UNITED STATES PATENT AND TRADEMARK OFFICE

APPLICATION NO.	FILING DATE	FIRST NAMED INVENTOR	ATTORNEY DOCKET NO.	CONFIRMATION NO.
10/606,493	06/26/2003	Burton Kozak	0052/01006 CIP	5600

Office Action Summary

DETAILED ACTION

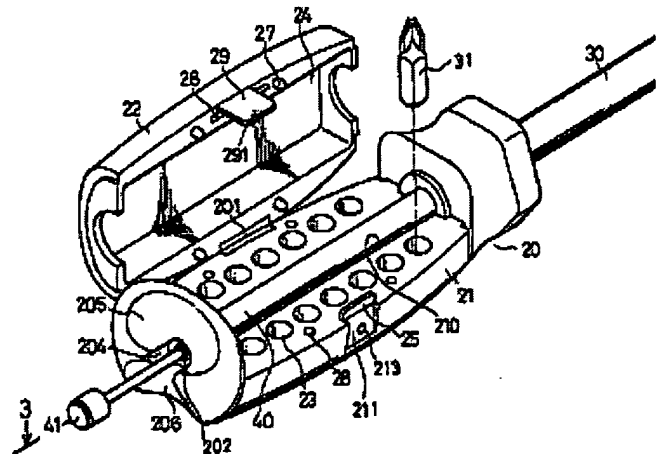
8. Claims 1, 2, 4, 5, 7, 10, 12, 13, 24 and 28 (as best understood) are rejected under 35 U.S.C. 102(b) as being clearly anticipated by Huang, US Patent No. 5,896,606.

Huang discloses all the limitations of claim 1, i.e. a combination driving and pick-up tool with a handle (20) a driving implement (21) and (30) and a pick-up implement (30) and (40) and means for facilitating the deployment comprising a cap (41)

magnetically attached to the member and in slidable communication with a periphery of the handle end.

Regarding claims 2, 4, 5, 7, 10, 12, 13, 24 and 28, Huang meet the limitations as best understood, e.g., cavities (23).

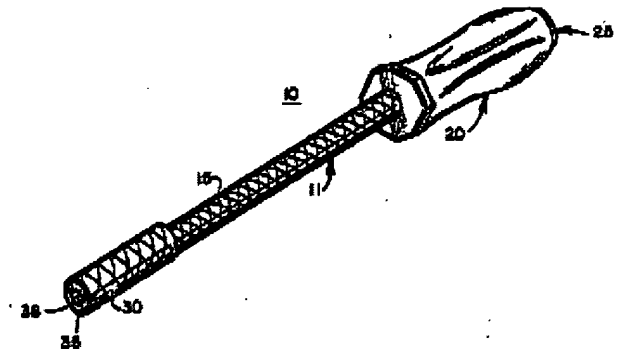
10. Claim 3 is rejected under 35 U.S.C. 103(a) as being unpatentable over Huang.

Huang discloses all the limitations of claim 3, except for a power driven tool. However, modifying manually driven screwdrivers to make the tool power driven is considered to be the knowledge of one of ordinary skill in the art, so it may be driven automatically, and since it has been held that broadly providing a mechanical or automatic means to replace manual activity which has accomplished the same result involves only routine skill in the art. *In re Venner*, 120 USPQ 192.
